JOB NO. MA24-04

LAHAINA SMALL BOAT HARBOR WATER SYSTEM LEAK ASSESSMENT AND REPAIR LAHAINA, MAUI, HAWAII

NOTE: THESE AS-BUILT PLANS HAVE BEEN MARKED UP TO SHOW THE SCOPE OF WORK FOR WATER SYTEM LEAK ASSESSMENT, PRESSURE TESTING, REPAIR AND NEW WATER SYSTEM WORK.

#### LAHAINA SMALL BOAT HARBOR WATER SYSTEM LEAK ASSESSMENT AND REPAIR

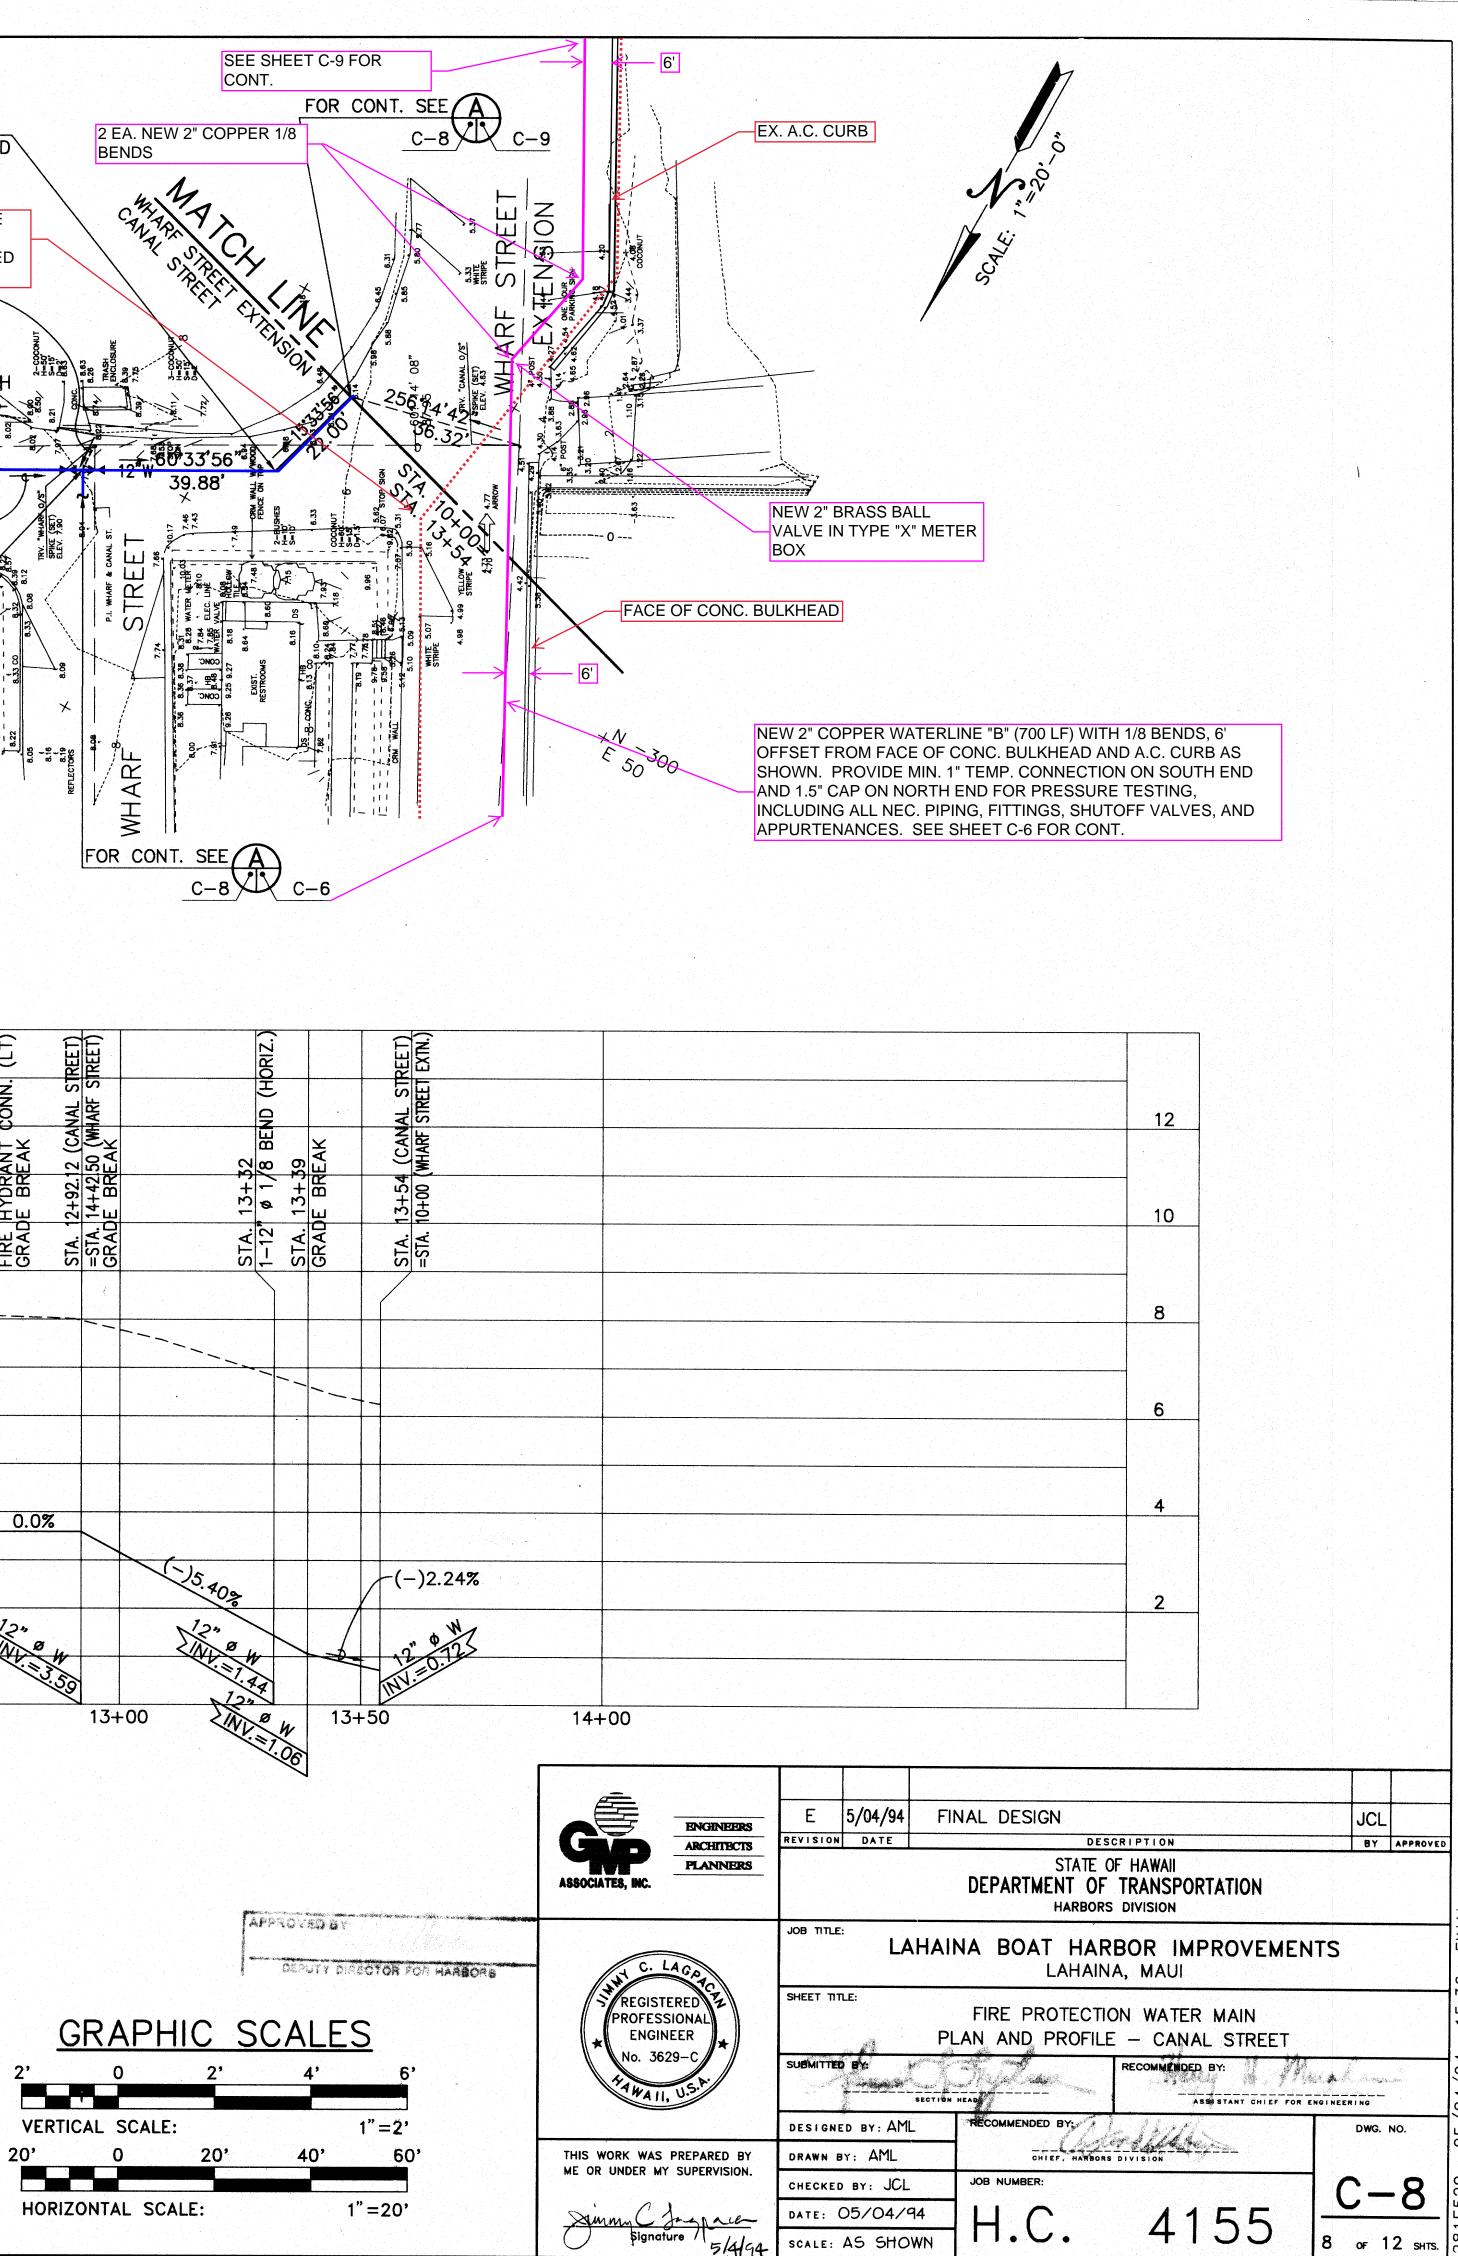
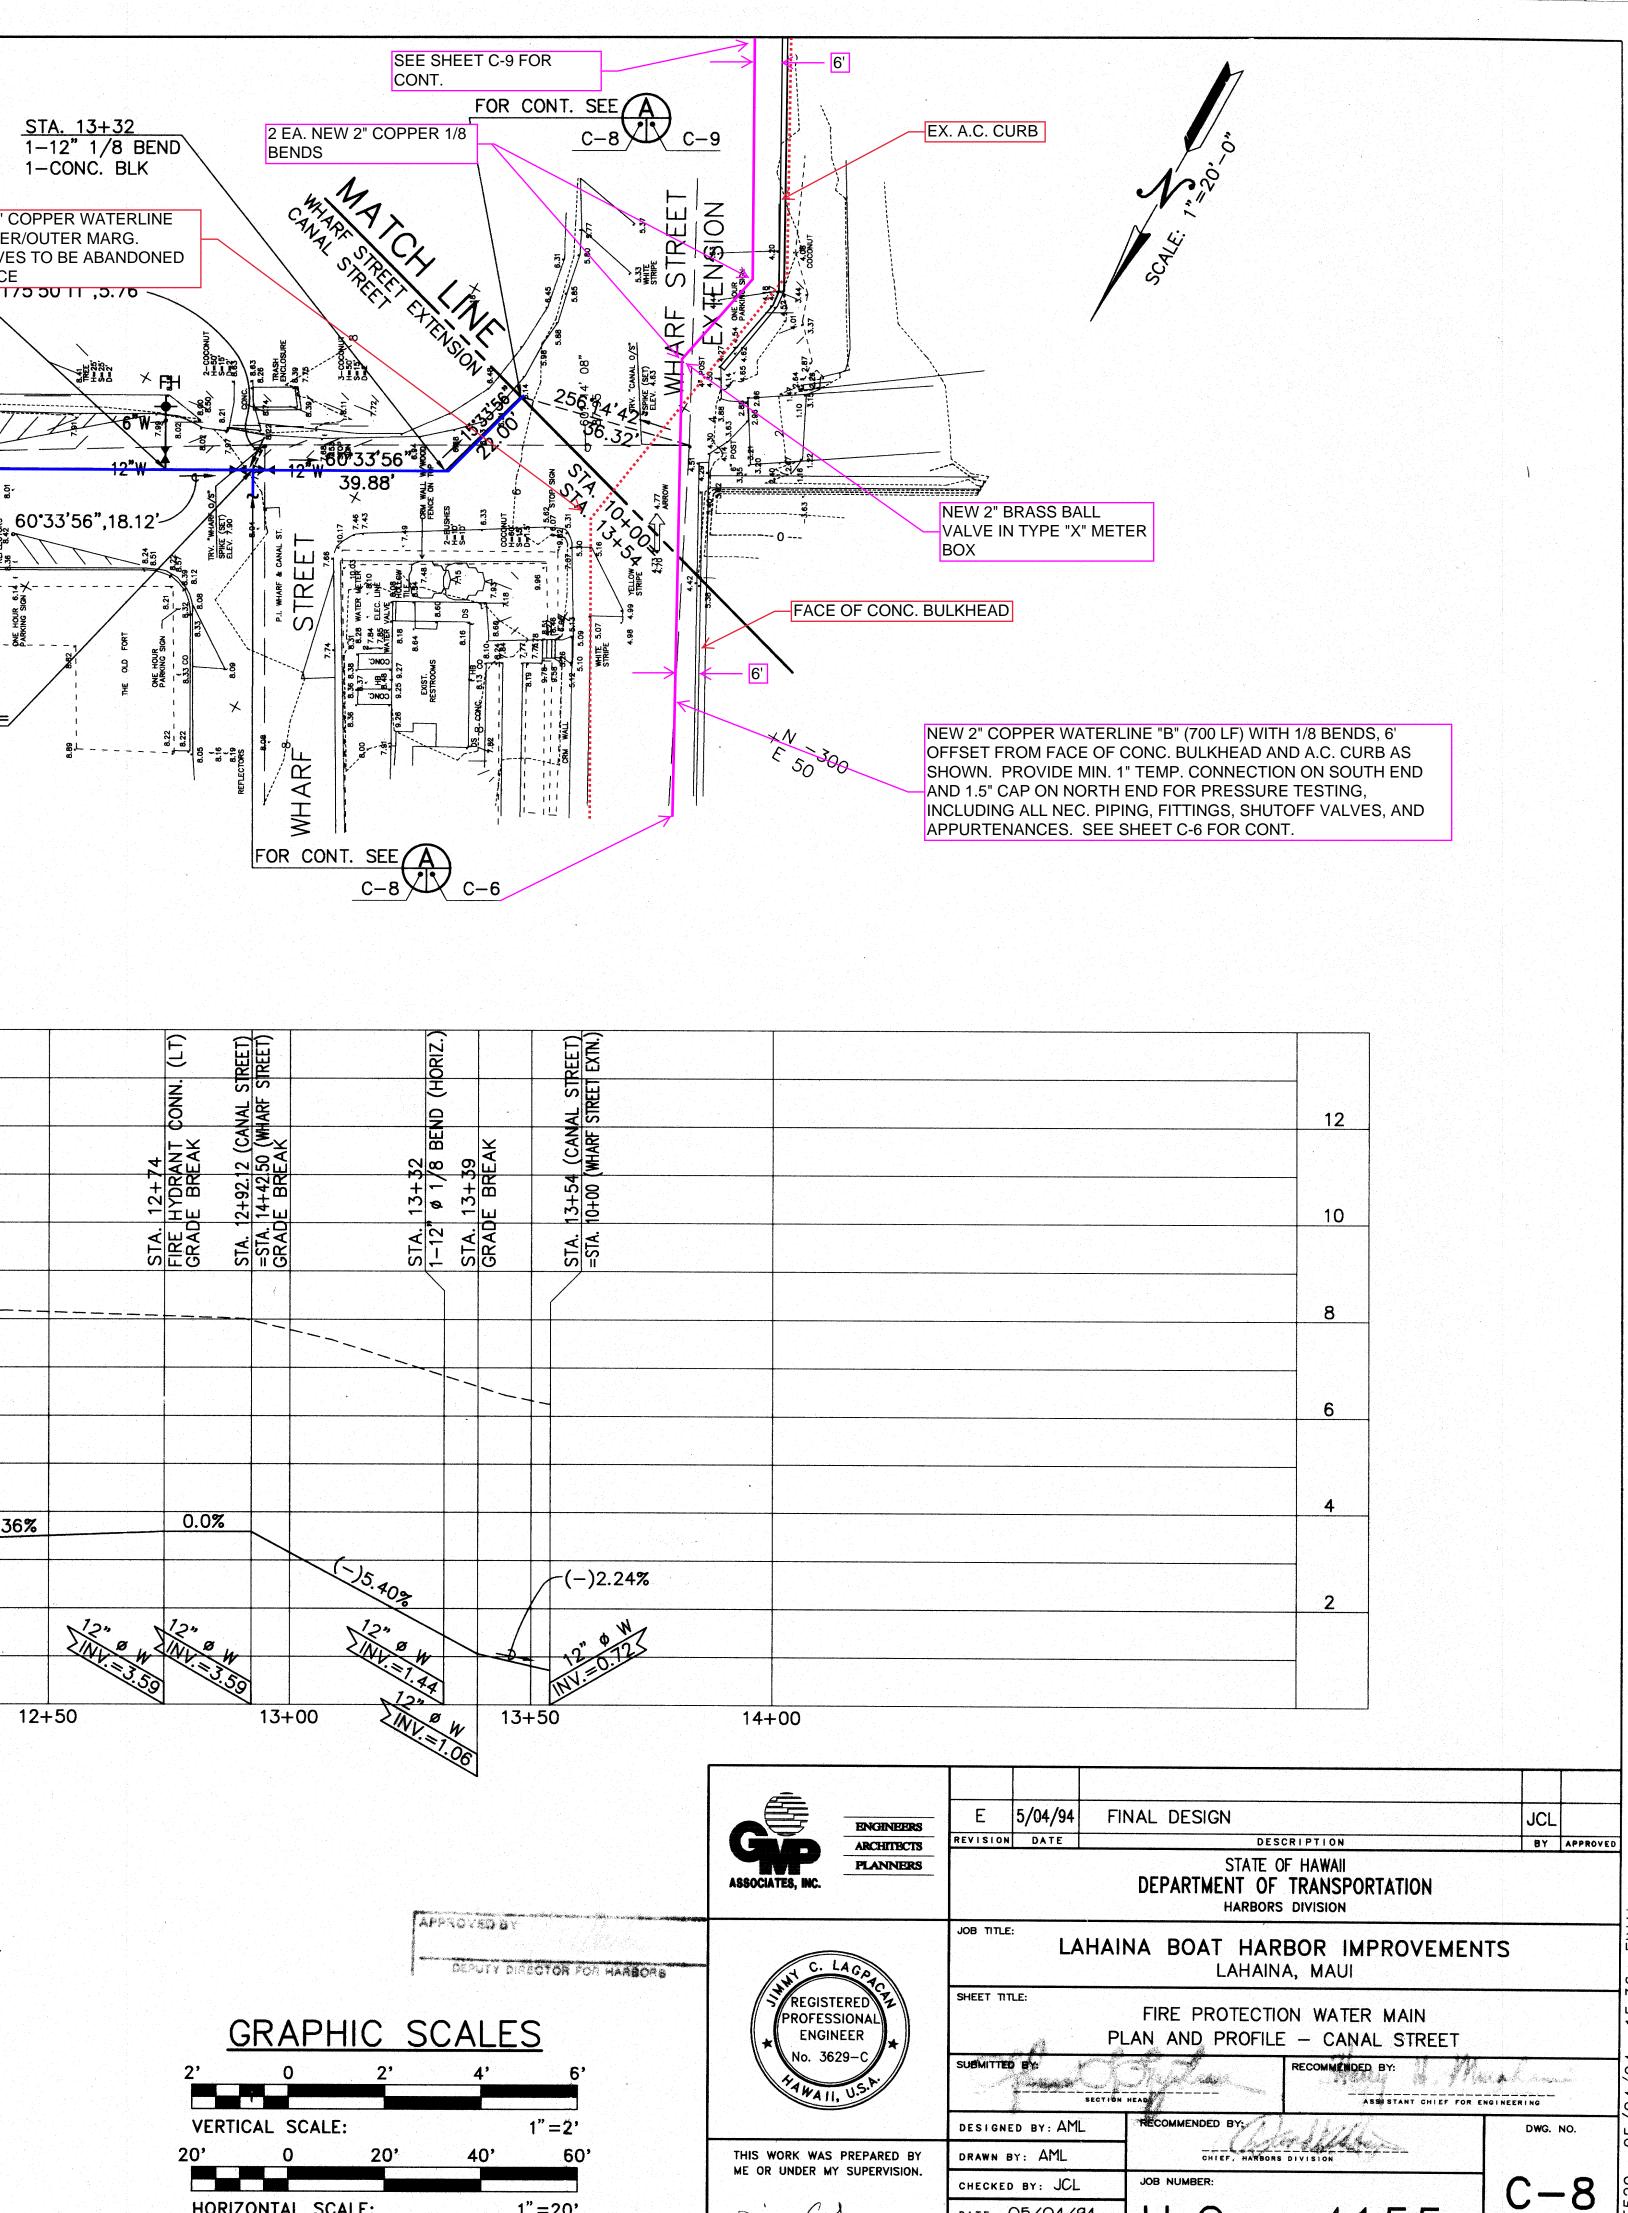
### NOTE: THIS SHEET FOR INFORMATION PURPOSES ONLY. NO LEAK
